SUBJECT: SALEM AND HOPE CREEK GENERATING STATIONS - FOLLOW UP
INSPECTION FOR POTENTIAL INADEQUACY OF SIMULATOR TESTING -
INSPECTION REPORT NOS 05000272/2004007; 05000311/2004007;
05000354/2004007

Report Nos: 05000272/2004007; 05000311/2004007; 05000354/2004007

Facility: Salem and Hope Creek Generating Stations

IR 05000272/2004007; 05000311/2004007; 05000354/2004007; 2/9/04 - 6/24/04; Salem / Hope Creek Generating Stations; IP 71111.11B Licensed Operator Requalification Program Inspection.

Figure 1, Containment Sump Level

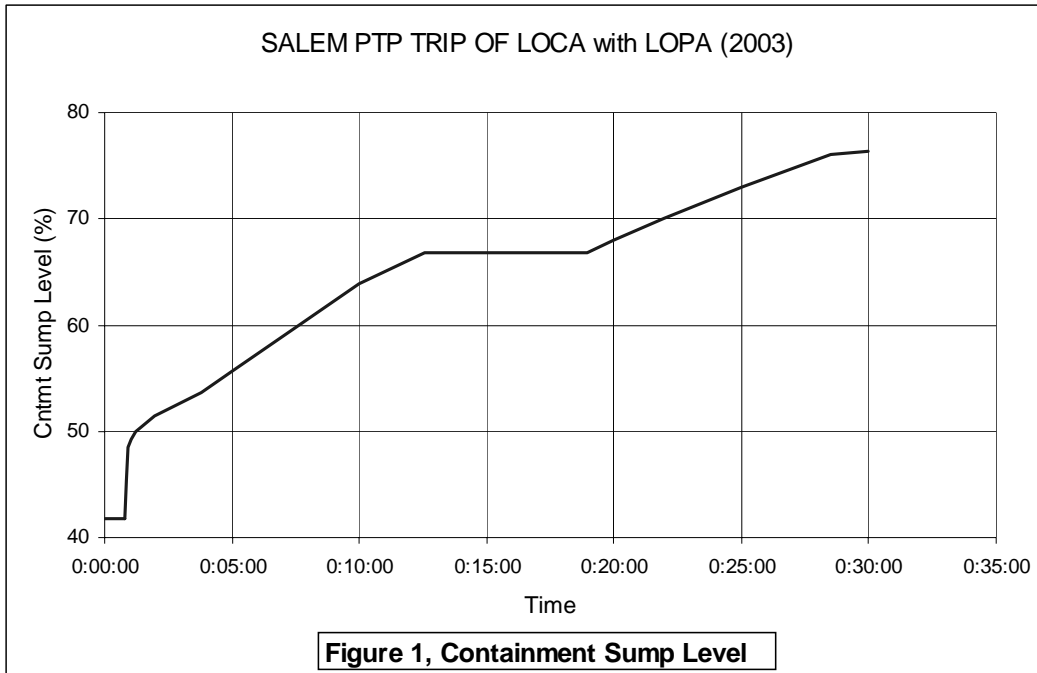
During review of simulator transient test data, the NRC identified a potential simulator fidelity/negative training issue. Inspectors questioned the indicated plateau in containment sump level during the injection phase of a large break loss of coolant accident simulation (see Figure 1). The plateau is observable in the Loss of Coolant Accident (LOCA) With Loss of Power (LOP) annual transient test results. It was determined that the plateau is based on the station's containment flood analysis.

A review of this calculation (Containment Volume Vs. Flood Level Analysis Design Calculation S-C-A900-MDC-0082, Rev. 1) shows that the plateau is expected to begin when the sump level reaches 81 feet 9 inches (approximately 67% indicated) because any further water addition to the sump will spill over into the area that provides access to the reactor sump and reactor coolant drain tank (RCDT) areas. The indicated level is calculated to remain at 81 feet 9 inches until 92,730 gallons of water spills over, filling the reactor sump and RCDT areas. This calculation assumes the water spills over primarily through a wire mesh door that acts to block entry into the area of the stairway to the reactor sump. Photographs were obtained from Radiation Protection showing

that, while Unit 1 has a wire mesh door, Unit 2 actually has a metal plate door. The assumption used in the calculation, that water will flow un-impeded through the closed door, is apparently not correct for Unit 2, which is the reference plant for the simulator. PSEG generated a condition report (CR #70037479) to review and correct the calculation and the erroneous drawing which states the Unit 2 door is wire mesh construction. The response documented in the condition report indicates that alternate paths exist for water to travel to the reactor sump and RCDT areas, other than through the door. These paths were not credited in the original calculation.

During the exit meeting, PSEG personnel explained that they will expedite the corrective action to revise the calculation and will forward results to the NRC. This item is unresolved pending a review of the revised containment flooding calculation and the simulator sump level response. **URI 05000272, 311/2004007-04, Salem Simulator Fidelity Concern Regarding Containment Level Response to Flooding.**
